INTERNATIONAL CODE COUNCIL

2012 – 2014 CODE
DEVELOPMENT CYCLE
Group C (2014)

PROPOSED CHANGES TO THE 2012 EDITIONS OF
THE INTERNATIONAL GREEN CONSTRUCTION CODE®

- General
- Energy/Water

FIGURE 505.3.1
HAIL EXPOSURE MAP

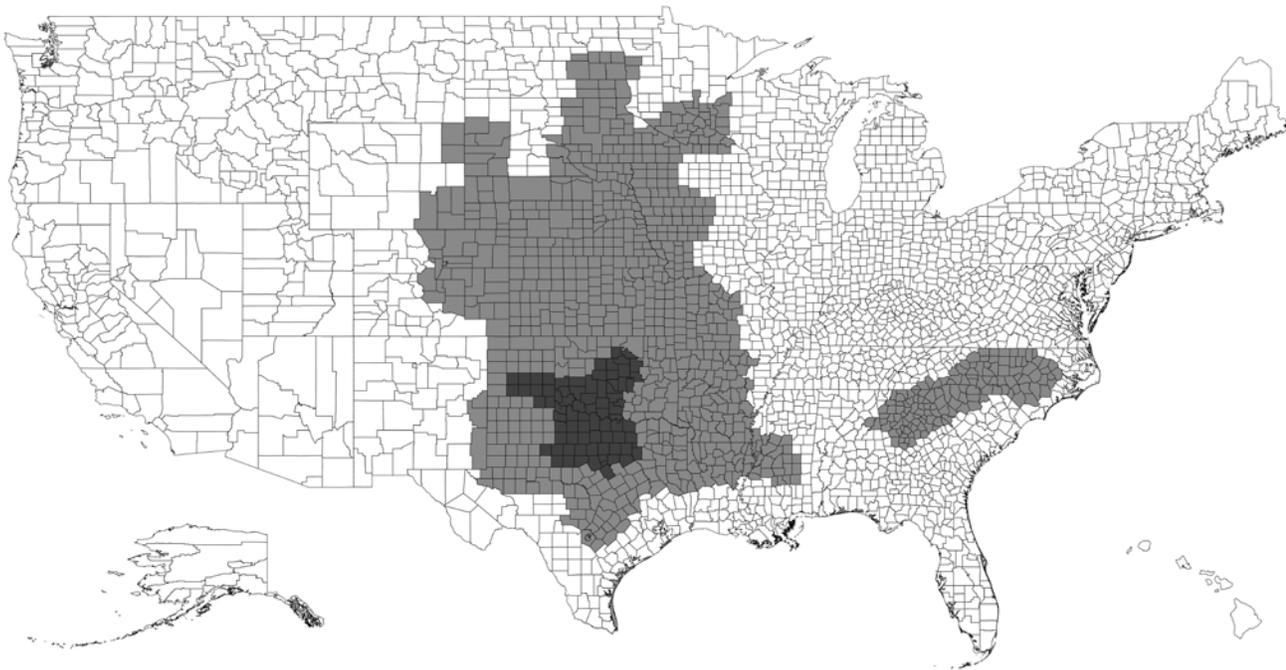
505.3 Roof coverings subject to hail exposure. Where indicated by Table 302.1, roof coverings used in regions where hail exposure is moderate or severe, as determined in accordance with Section 505.3.1 and Figure 505.3 shall be tested, listed, and labeled as Class 3 or Class 4 respectively in accordance with UL2218.

505.3.1 Hail exposure regions. Hail Exposure regions in Figure 505.3.1 shall be as follows:

1. Moderate - One or more hail days with hail diameters greater than 1.5 in (38 mm) in a 20 year period.
2. Severe - One or more hail days with hail diameters greater than 2.0 in (50 mm) in a 20 year period.

New Figure 505.3 is from the 2009 edition of the IRC, Figure R903.5.

FIGURE 804.3

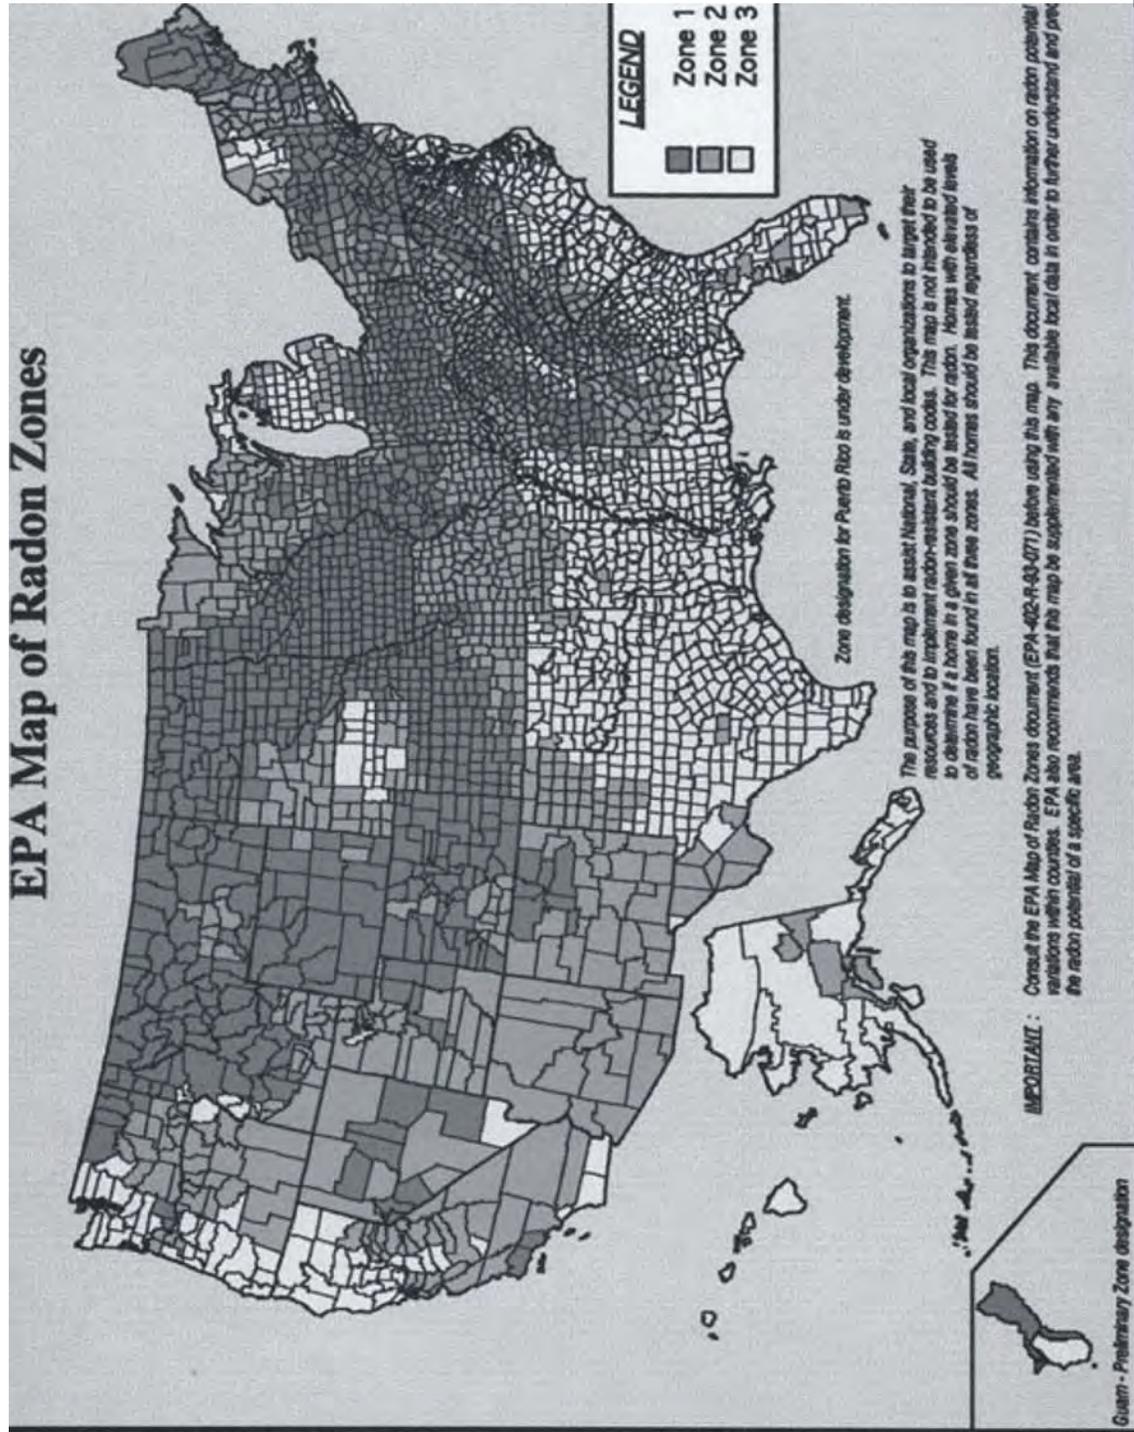
804.3 Radon Testing Where a building site indicates a potential for elevated indoor *radon* concentrations, as shown by the United States Environmental Protection Agency zones 1 and 2 in Figure 804.3 or from the United States Environmental Protection Agency *radon* potential by county listing in Table 804.3, *radon* testing shall be performed prior to occupancy of the building. Such testing shall be performed by a *qualified radon* measurement professional. Where state or local jurisdictions have published radon potential data, such data shall supersede the information in Figure 804.3 and Table 804.3. Indoor radon levels shall not exceed the United States Environmental Protection Agency Radon Action Level of 4 pCi/L.

FIGURE 809.1
EPA MAP OF RADON ZONES

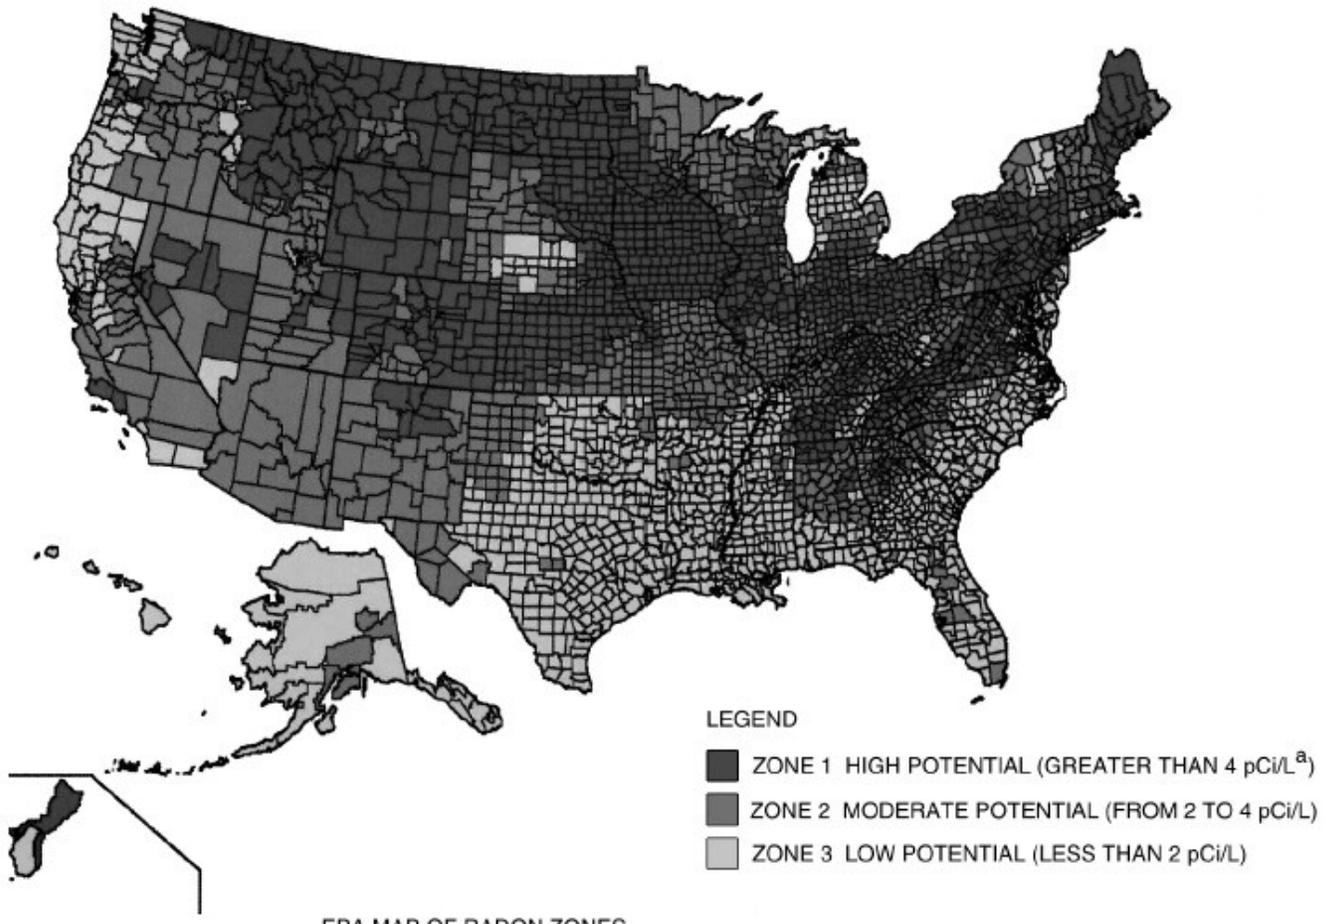
809.2 Mitigation system required. A *rough-in* or complete *active soil depressurization* system shall be installed in accordance with AARST/ANSI CCAH-2013 in dwellings that are located in *radon* potential zones 1 and 2 in accordance with Section 809.3.

809.3EPA established zones. The radon potential of a building site shall be estimated from the United States Environmental Protection Agency radon potential map as shown in Figure 809.1 or from United States Environmental Protection Agency radon potential by county listing as shown in Table 809.1. Where state or local jurisdictions have published radon potential data, such data shall supersede the information in Figure 809.1 and Table 809.1.

FIGURE B101.1 FIGURE 809.1
EPA MAP OF RADON ZONES

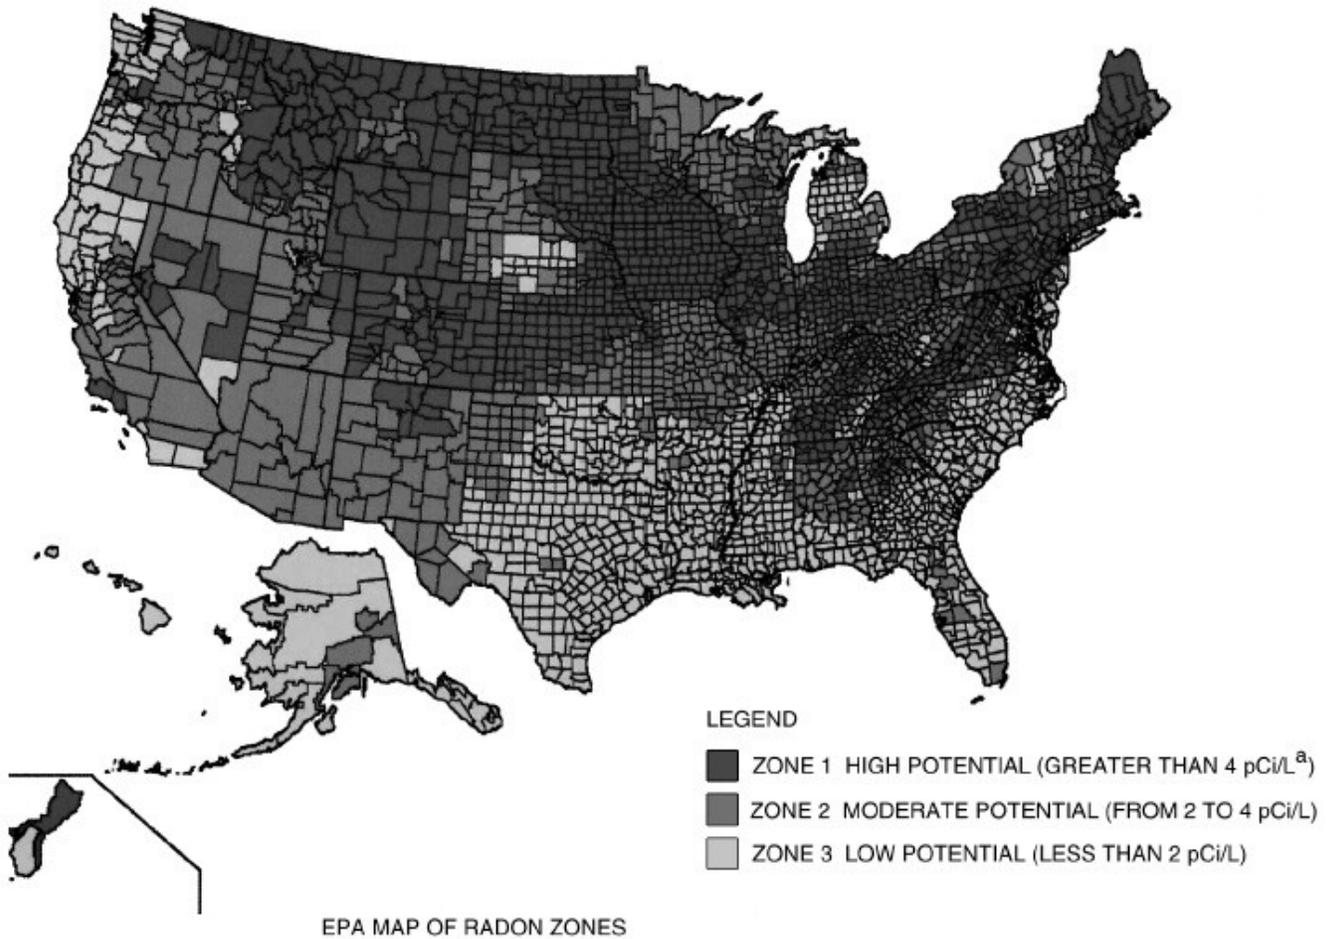
B101-809.1 Radon mitigation. Buildings in areas of High and Moderate Radon Potential (Zone 1 and 2), as determined by Figure 809.1 B101.4 and Table 809.1 B101.4 shall comply with Sections 809.2.1 B201.1 through 809.2.12 B201.10.

Figure 1 Increase in Property Losses Due to Natural Disasters, excluding Flood¹

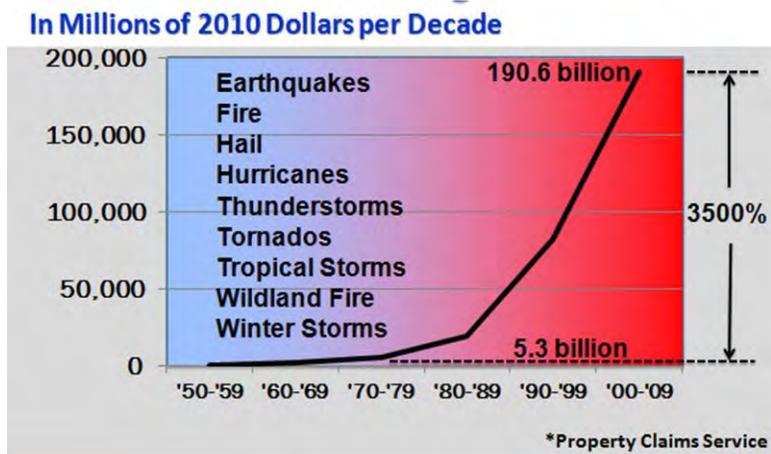
While there has not been a proportionate increase in either frequency of events (which have remained relatively constant) construction put in place (which has maintained an upward trend of trend of 10% per decade or 40% over last four decades) or demographics (population growth even in the fastest growing regions has 10% per decade or 40% over the same time period) property losses due to natural disasters, adjusted to 2010 dollars, have increased by over a staggering 3500%, see Figure 1. Losses from fire, adjusted to 2010 dollars, have increased by 85% per fire, see Figure 2.

Figure 1 Legionella Transmission: Factors and events leading to Legionnaires' disease.

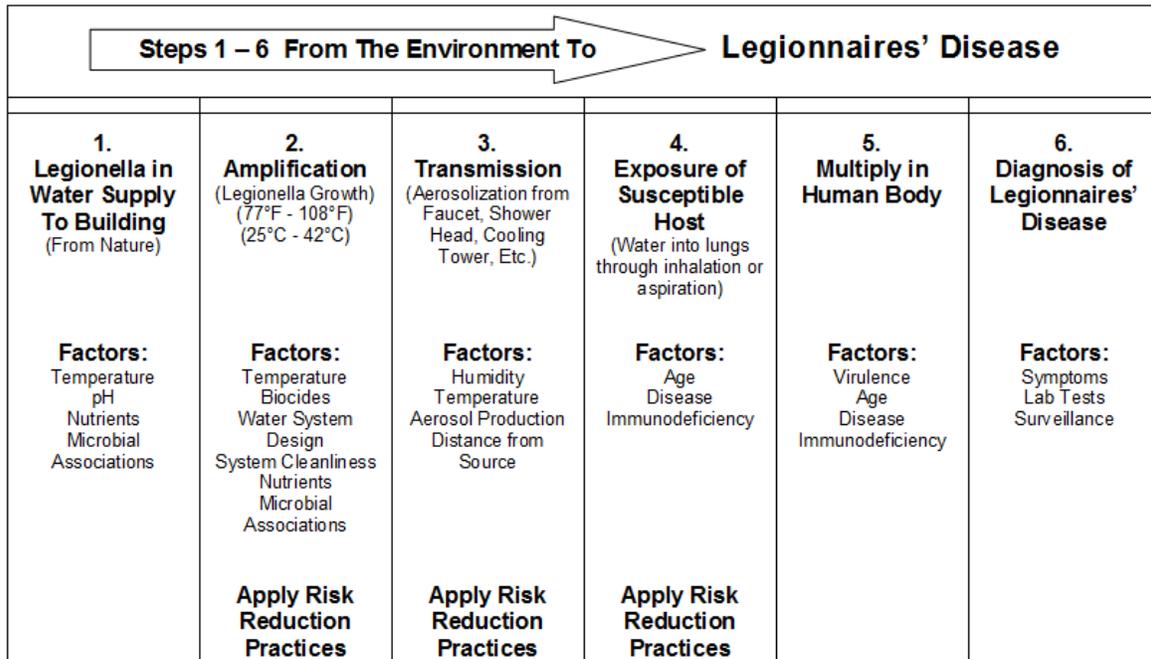
Reason: Legionellosis is a recognized hazard that can kill or cause serious physical harm to building occupants. The term Legionellosis refers collectively to two distinct clinical illnesses, Legionnaires' disease and Pontiac fever. Legionnaires' disease is when the bacterium Legionella causes severe pneumonia. Pontiac fever is when Legionella infection results in a less severe, non-pneumonic, influenza-like illness. The US Centers for Disease Control and Prevention (CDC) has estimated that there are between 8,000 and 18,000 cases of Legionnaires' disease in the United States each year, and that more than 10 percent of these cases are fatal. Legionellosis results predominantly from exposure to Legionella associated with building water systems. Estimates suggest that 20% of Legionnaires' disease cases are outbreak related (more than one confirmed case in a one year period), but the majority are not outbreak-related (sporadic) (MMWR 2011). Outbreaks have been associated with whirlpool spas, cooling towers, decorative fountains, hotels, water systems of hospitals and nursing homes, and cruise ships. Persons at increased risk for legionellosis include, but are not limited to, the elderly, dialysis patients, persons who smoke, and persons with underlying medical conditions that weaken the immune system. However, a significant percentage of cases are in persons that are not part of any identified at-risk population. Building water systems vary substantially in their design and propensity for transmission of Legionella. Conditions that are favorable for the amplification of legionellae growth include the presence of other bacteria, amoebae and other protozoan hosts, water temperatures of 25-42°C (77-108°F), stagnation, scale, sediment and biofilms. Legionellosis is not transmitted person-to-person. Multiple modes have been identified for transmission of *Legionella* to humans; there is evidence for aerosolization, aspiration, and direct instillation into the lung during medical procedures. In most instances, transmission to humans occurs when water that contains *Legionella* is aerosolized in respirable droplets
